SOUTHEASTERN WISCONSIN REGIONAL PLANNING COMMISSION

MEMORANDUM

SUBJECT: SOUTHEAST WISCONSIN 2015 LIDAR (SEWI_5)

Appendix

Milwaukee County – NAD27 / NGVD29

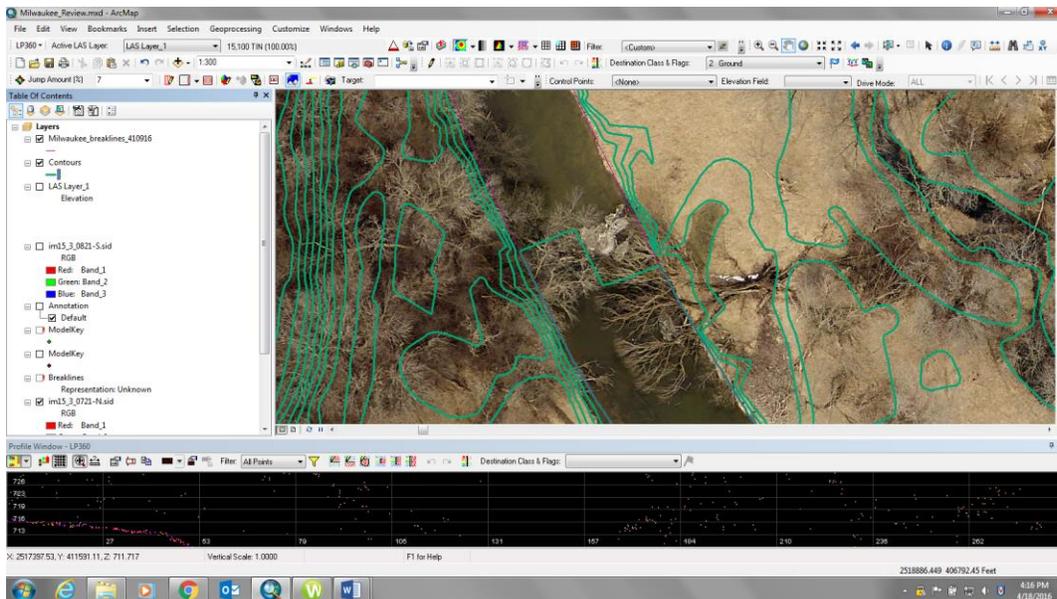
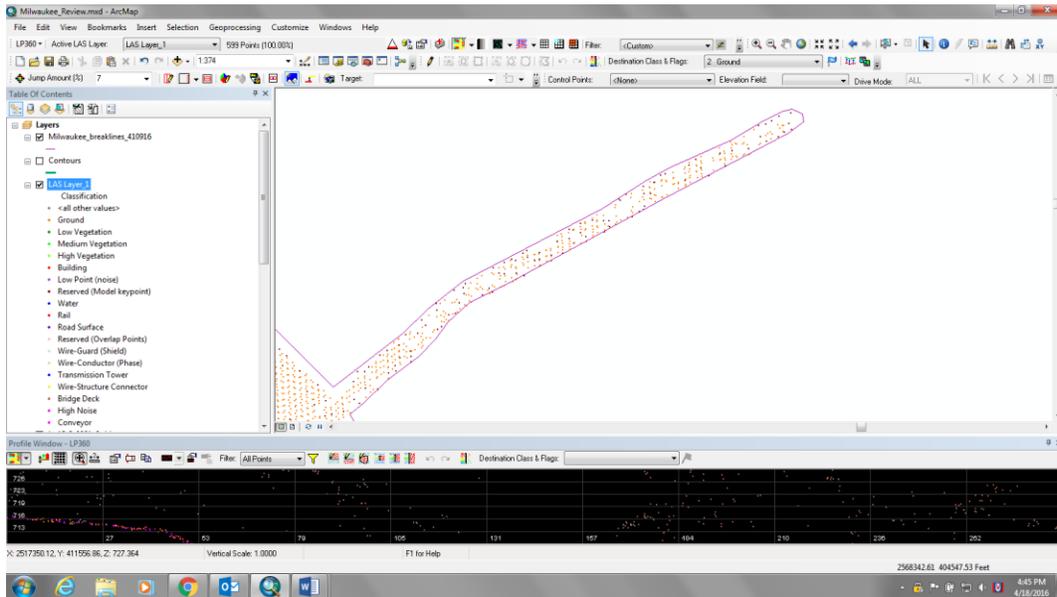
Points outside of breakline. Shoreline has points cleared but the breakwater wall did not have any points cleared away from breakline.

ND83/2011 TILE (Id15_BE_2460_450_NAD83-2011.las)

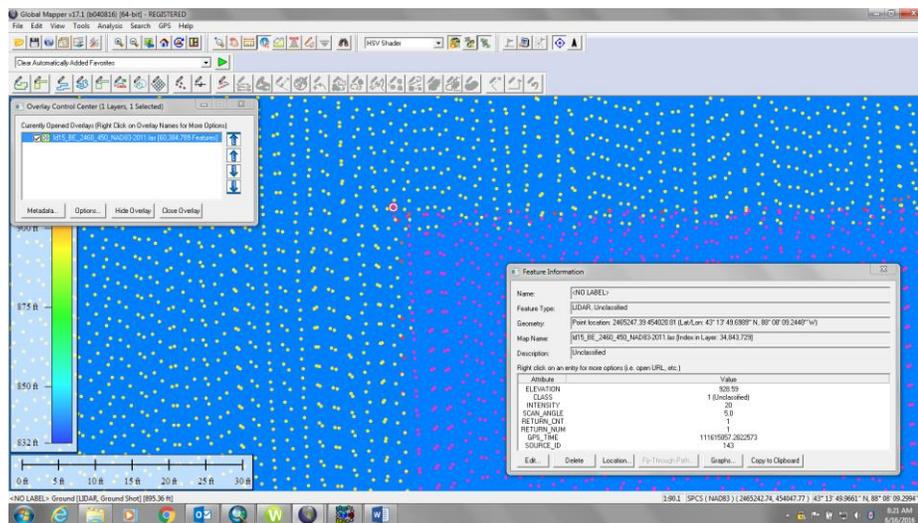
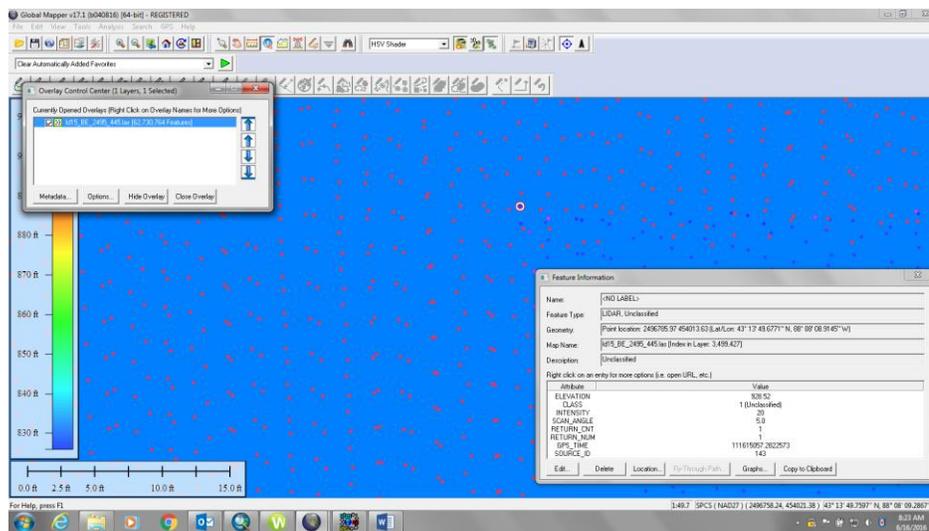
Converting from NAD83/2011 to NAD27, the sample point computed found is inconsistent between datums:

NAD83/2011 Tile (Id15_BE_2380_440_NAD83-2011.las)

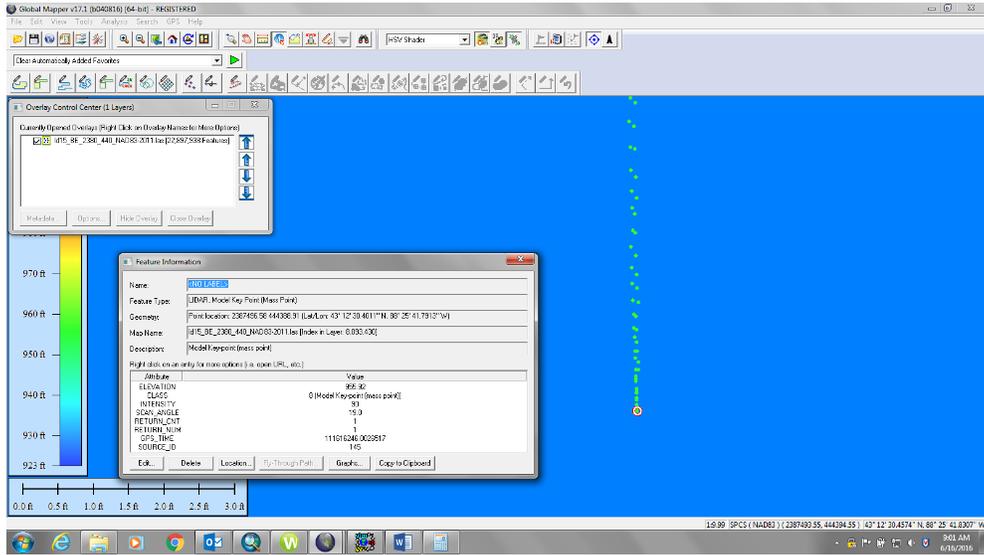
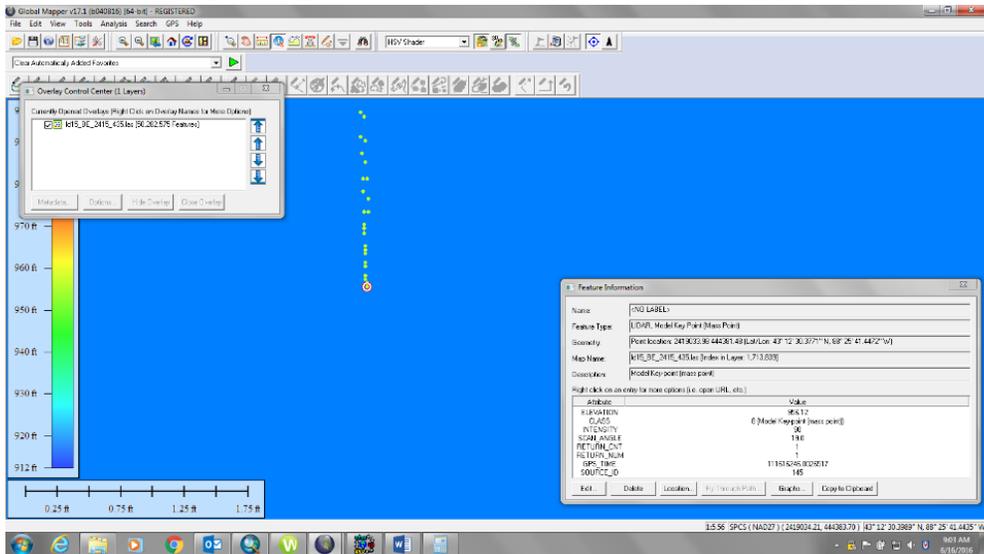
Converting from NAD83/2011 to NAD27, the sample point computed found is inconsistent between datums:
